PCN-20190112 TEB0911-04-* SPI Flash and eMMC Change

Company	Trenz Electronic GmbH
PCN Number	PCN-20190112
Title	TEB0911-04-* SPI Flash and eMMC Change
Subject	BOM change
Issue Date	2019-09-09

#3 Change R65 to 1K

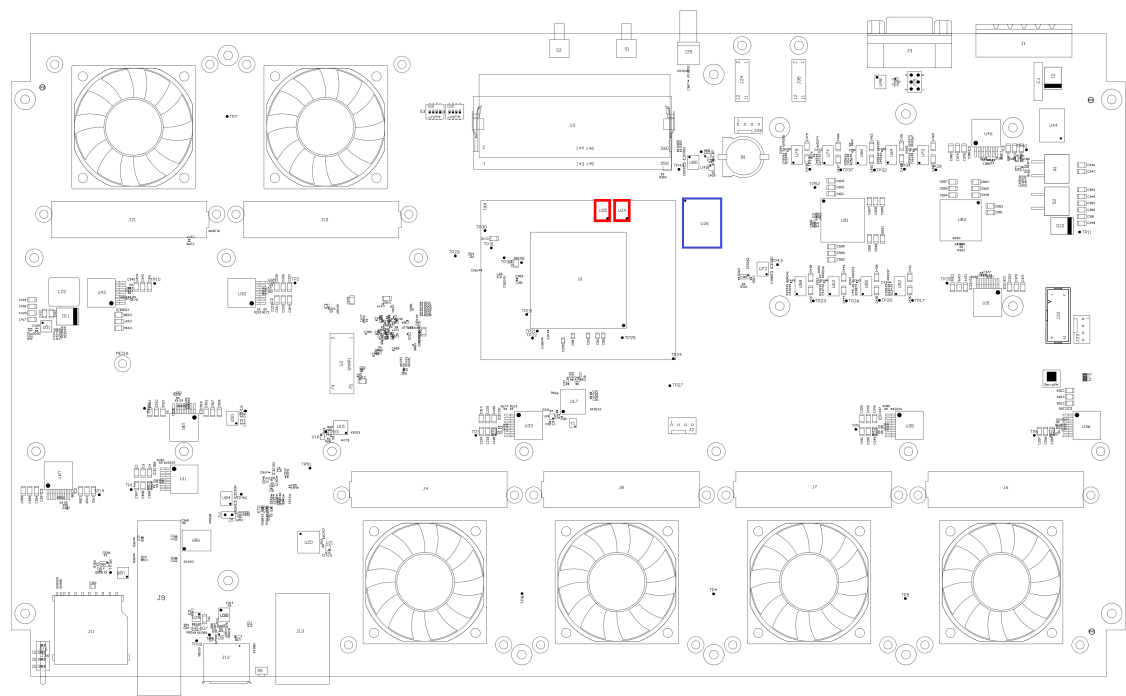
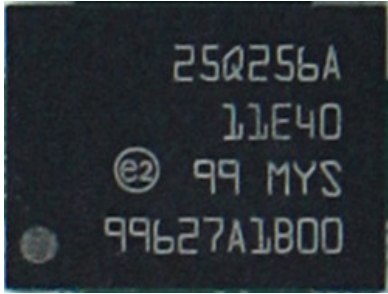
Type: BOM change

Reason: USB connection problem on some carriers reported

Impact: USB connection works reliable
